**SUBDIVISION COMMITTEE  
METROPOLITAN AREA PLANNING COMMISSION**

**STAFF REPORT  
(Final Plat)**

**CASE NUMBER:** S/D 94-18 KELLOGG WEST SQUARE ADDITION

(Revised Final Plat, Final Plat Approved 3/17/94)

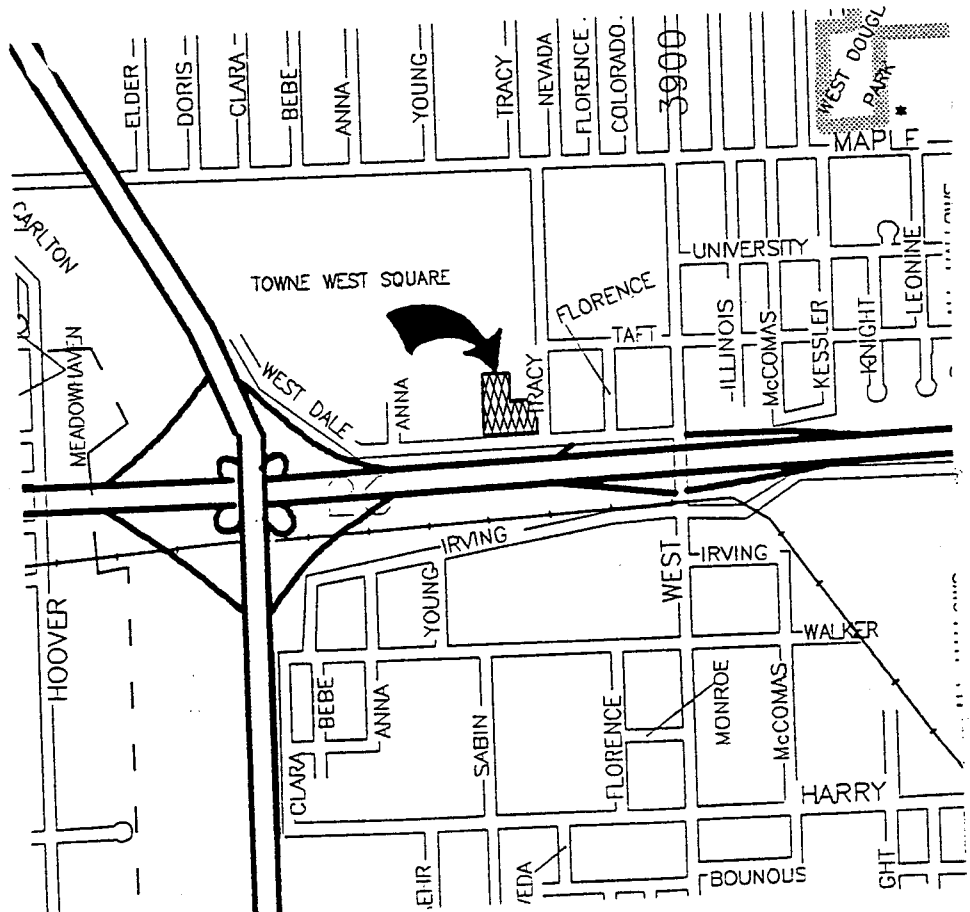
- A. The applicant shall guarantee the extension of sanitary sewer to serve the lots being platted. This guarantee shall also provide for any abandonment or relocation of existing facilities.

- B. The applicant shall guarantee the extension of City water to serve the lots being platted. This guarantee shall also provide for any abandonment or relocation of existing facilities.

- C. The applicant shall guarantee any drainage improvements required by the platting of this property.
- D. If improvements are guaranteed by petition, a notarized certificate listing the petitions shall be submitted to the Planning Department for recording.

- E. City Engineering needs to indicate if the easements shown for water and sanitary sewer are adequate.
- F. Based on this replat, Lot 1 will not have direct access to a public street. The applicant shall either provide proof that this site has an acceptable, legally established means of access to a public street or the applicant shall establish or obtain such access. Proof of such access shall be provided to Planning. If an easement is to be provided on this site, such easement needs to be shown on the final plat tracing.

- G. On the final plat tracing, the dedication of street right-of-way (for Tracy) shall be noted in the plattor's text with it being indicated that the street is dedicated to and for the use of the public.

- H. If this plat is vacating any easements, setbacks, etc., the surveyor's text should reference such replatting by noting K.S.A. 512(b) as amended.
- I. The face of the plat and plattor's text shall be amended to properly indicate the access controls being shown to Kellogg Drive. The face of the plat and text shall note that access control is being dedicated except for one opening per lot (Lot 2 and 3). The plattor's text shall further note that the location of the openings shall be approved by the City Engineer.

- J. Prior to this plat being scheduled for City Council review, the applicant shall submit a letter indicating that any portion of the building in the southeast corner of Lot 3, shown as presently encroaching street right-of-way has been removed.

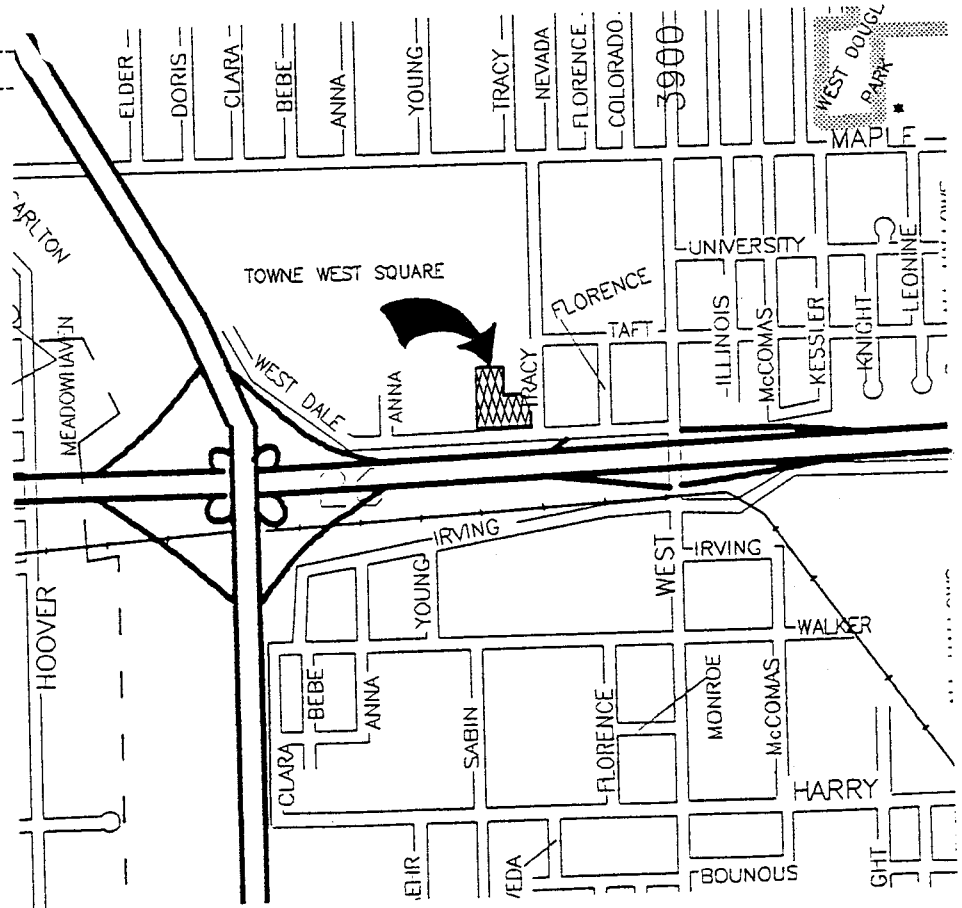
- A. The applicant shall guarantee the extension of sanitary sewer to serve the lots being platted. This guarantee shall also provide for any abandonment or relocation of existing facilities.

- B. The applicant shall guarantee the extension of City water to serve the lots being platted. This guarantee shall also provide for any abandonment or relocation of existing facilities.

- C. The applicant shall guarantee any drainage improvements required by the platting of this property.
- D. If improvements are guaranteed by petition, a notarized certificate listing the petitions shall be submitted to the Planning Department for recording.

- E. ~~On the final plat tracing, a 15-foot easement was to be indicated along the east line of Lot 1. Engineering and the utilities need to indicate if this easement is still needed.~~

- F. Based on this revised plat, Lot 1 will not have adequate access to a public street. The applicant shall either provide proof that this site has an acceptable, legally established means of access to a public street or the applicant shall establish or obtain such access. Proof of such access shall be provided to Planning. If an easement is to be provided on this site, such easement needs to be shown on the final plat tracing.

- G. Kellogg Drive along the east line of Lots 2 and 1 is a dedicated public street and consequently a building setback is expected adjacent to this street. While a 35-foot setback may not be needed, a 20-foot setback shall be platted on Lots 1 & 2, adjacent to Kellogg Drive.

- H. If this plat is vacating any easements, setbacks, etc., the surveyor's text should reference such replatting by noting K.S.A. 512(b) as amended.
- I. Prior to this plat being scheduled for City Council review, the applicant shall submit a letter indicating that any portion of the building in the southeast corner of Lot 3, shown as presently encroaching street right-of-way has been removed or is planned to be removed shortly.
